FECAL COLIFORM BACTERIA TOTAL MAXIMUM DAILY LOAD EVALUATION
FOR BRULE CREEK, UNION COUNTY, SOUTH DAKOTA

**South Dakota Department of
Environment and Natural Resources**

Appendix A**EPA REGION VIII TMDL REVIEW**

Document Name:	Fecal Coliform Bacteria Total Maximum Daily Load Evaluation for Brule Creek, Union County, South Dakota
Submitted by:	Cheryl Saunders, SD DENR
Date Received:	March 24, 2011
Review Date:	April 6, 2011
Reviewer:	Vern Berry, EPA
Rough Draft / Public Notice / Final?	Public Notice Draft
Notes:

Figure 2. Brule Creek Fecal Coliform Bacteria Load Duration Curve

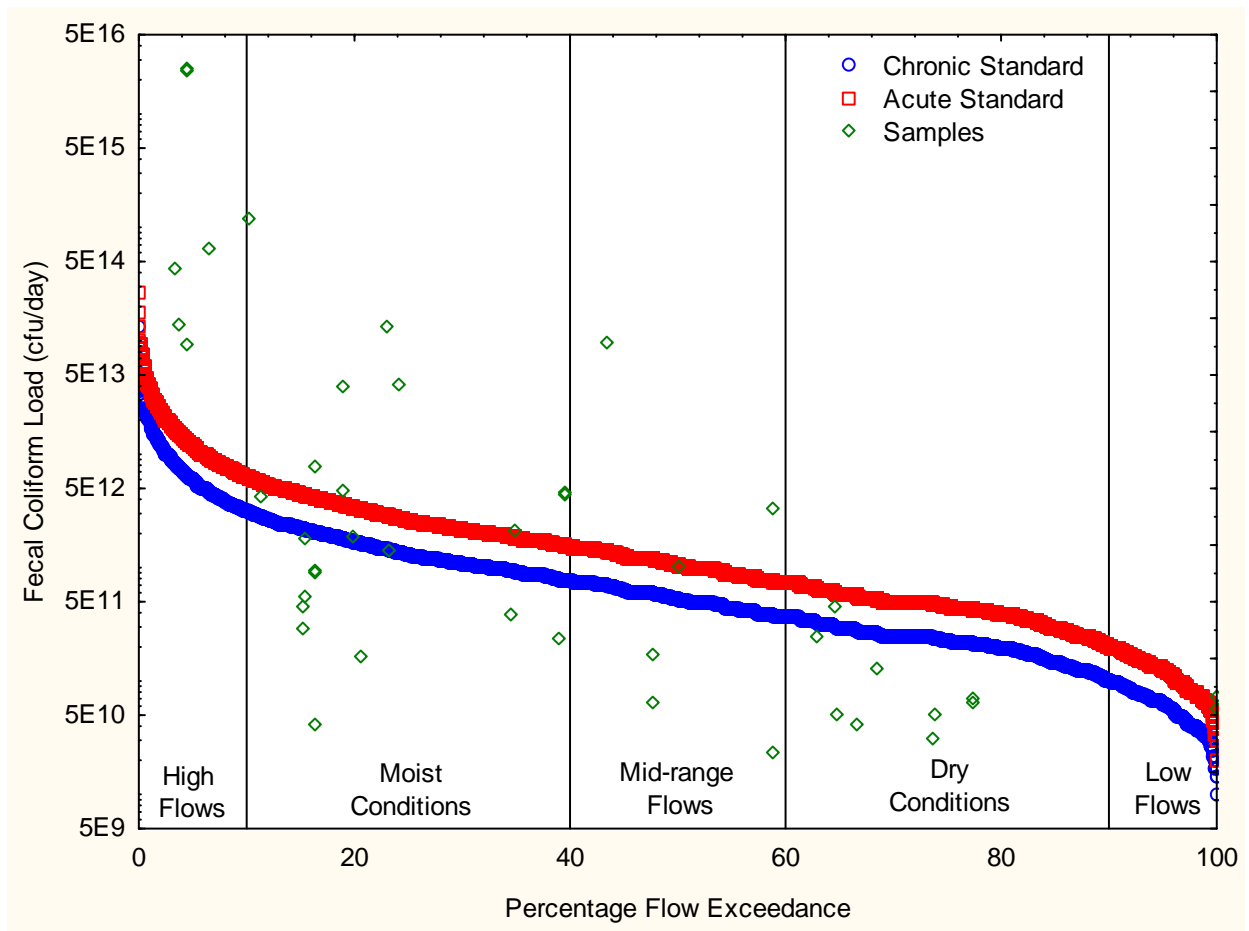
COMMENTS: Section 4.2 of the TMDL document mentions using 5 flow zones in the load duration curve. It would be helpful to show the vertical zone lines for each zone on the LDC in Figure 2. Also, the LDC tables in Section 5 do not include a table or subsection for the low flow zone (90 – 100% exceedance). Also, it's generally not necessary to include 5 significant figures when expressing loads in scientific notation as was done in Tables 8-11. The TMDL should be revised to addresses these issues.

Remedy: A subsection and table for the low flow zone was added. A low flow zone was not included in the original report due to errors caused by using instantaneous flows. Using average daily flows resolved the issue and allowed for inclusion of the low flow zone. In addition, the number of significant figures in loads expressed with scientific notation (Tables 8-11) were decreased.
